Report on Two Generation Expansion Alternatives for the Island Interconnected Electrical System

Volume 2: Studies

Prepared for:
Board of Commissioners of Public Utilities
Newfoundland and Labrador

Prepared by:
Manitoba Hydro International Ltd.
211 Commerce Drive
Winnipeg, Manitoba R3P 1A3, Canada
www.mhi.ca

Figure 1: Domestic Energy Sales³

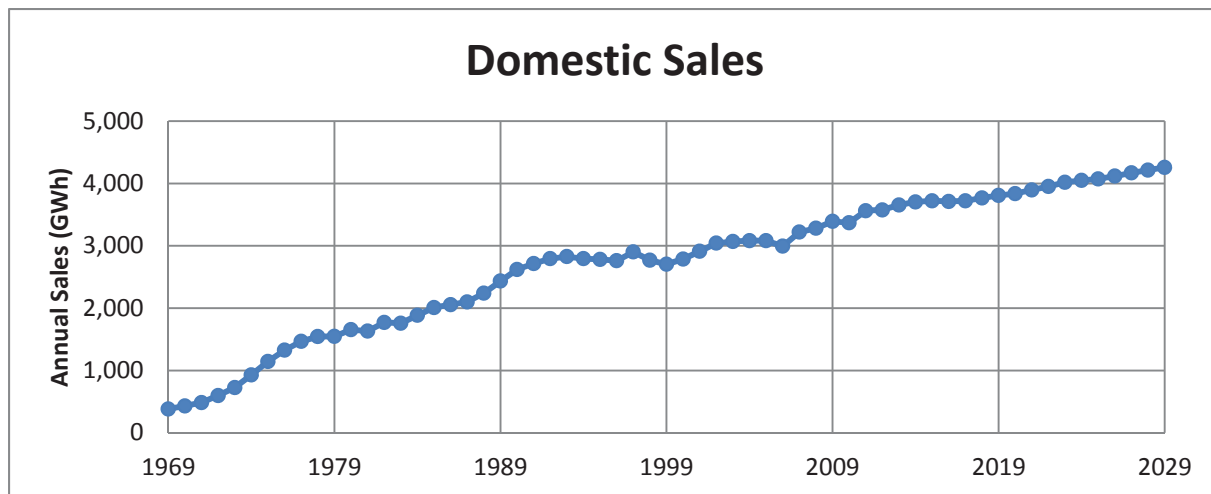
Figure 1 shows that the domestic sector grew rapidly over the 1969-1993 period and remained relatively flat during 1993-1999 due to the economic downturn. Since 1999, the domestic electricity consumption has grown steadily due to increasing levels of housing, income and electric space heat.

Table 1 shows that the domestic electricity forecast increases 38 GWh per year during the forecast period. This growth is 51% lower than the 78 GWh per year experienced in the last 40 years and 39% lower than the 62 GWh experienced in the last decade.

Figure 2: General Service Sales¹¹

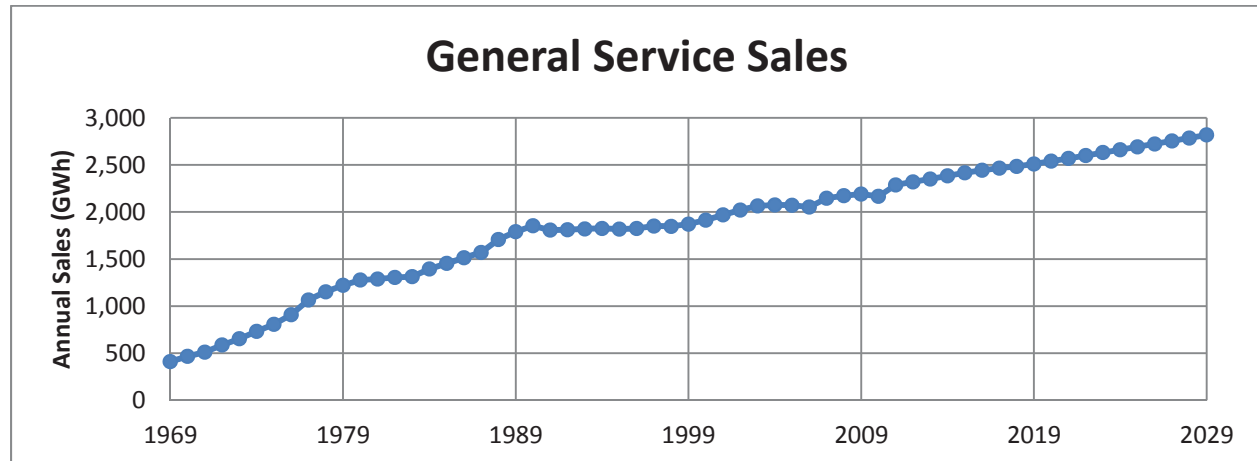
Figure 2 shows that the general service sector grew rapidly over the 1970-1990 period and remained relatively flat during the 1990's, as GDP and commercial business investment stalled. Since 1999, the general service load has grown at a steady, slow rate due to increasing levels of construction activity, GDP, commercial business investment and furnace oil prices, which make electric heat more desirable.

Table 5 shows that general service electricity consumption is forecast to increase 32 GWh per year. Forecast growth is 27% lower than the 44 GWh per year experienced over the last forty years or 23% higher than growth experienced in the last decade. The general service forecast is primarily based on slower levels of gross domestic product (GDP) growth and higher levels of commercial business investment growth provided by the Department of Finance and are shown in the Key Economic Assumptions section 1.7.

Figure 3: Industrial Sector Energy Sales¹⁴

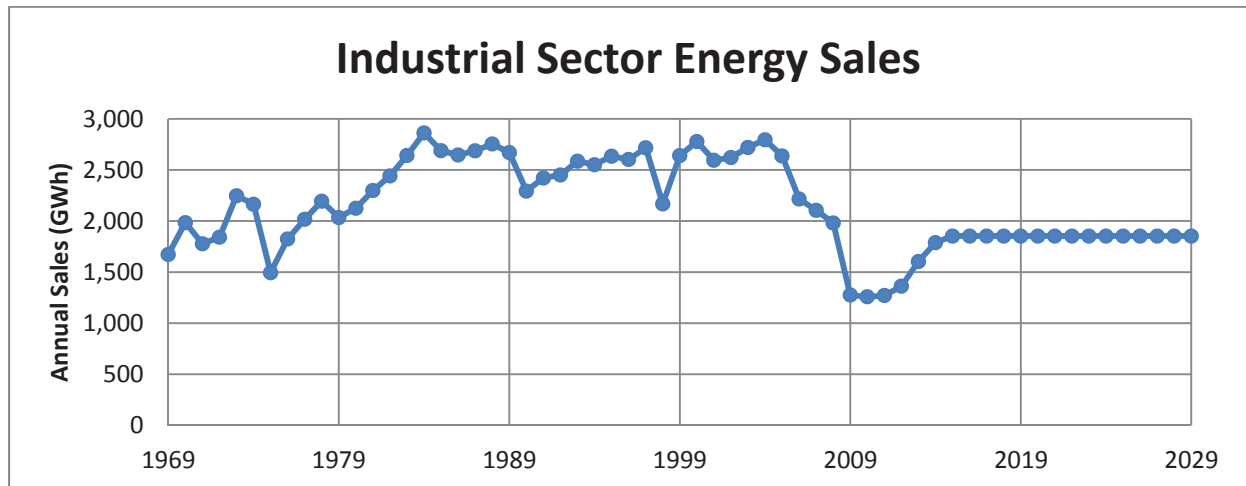
Figure 3 shows that the industrial sector grew rapidly over the 1975-1984 period and fluctuated, but remained relatively constant throughout 1984-2005. Since 2005, the industrial load has declined sharply due to the closure of two Abitibi pulp and paper mills at Stephenville (2006) and at Grand Falls (2009).

Table 7 shows that the industrial forecast predicts that electricity consumption will grow 31 GWh per year. This growth is specifically associated with the Vale hydrometallurgical load coming online during the 2013-2015 period. The load remains constant after 2015. Industrial consumption decreased an average of 152 GWh per year in the last decade, primarily due to pulp and paper mill closures.

Figure 7: Interconnected Island Peak Demand²⁶

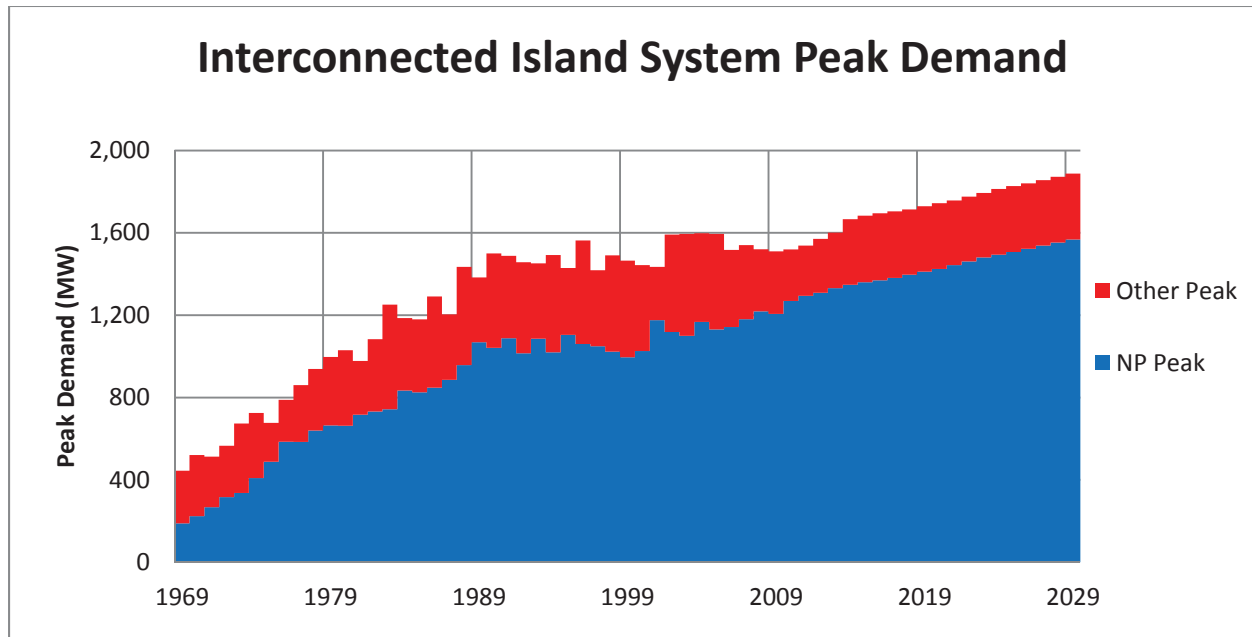
Figure 7 shows that the interconnected island peak demand grew rapidly over the 1970-1990 period as the NP electric heat saturation rate increased from 4% to 48%. The peak remained relatively constant throughout the 1990's as electric heat growth was offset by economic stagnation. When the economy recovered, the peak started to grow again, until the two mill closures in 2006 and 2009.

Figure 7 also shows that the NP peak forecast is the most significant (80%) contributor to the interconnected island system peak forecast and has accounted for almost all of the peak load growth
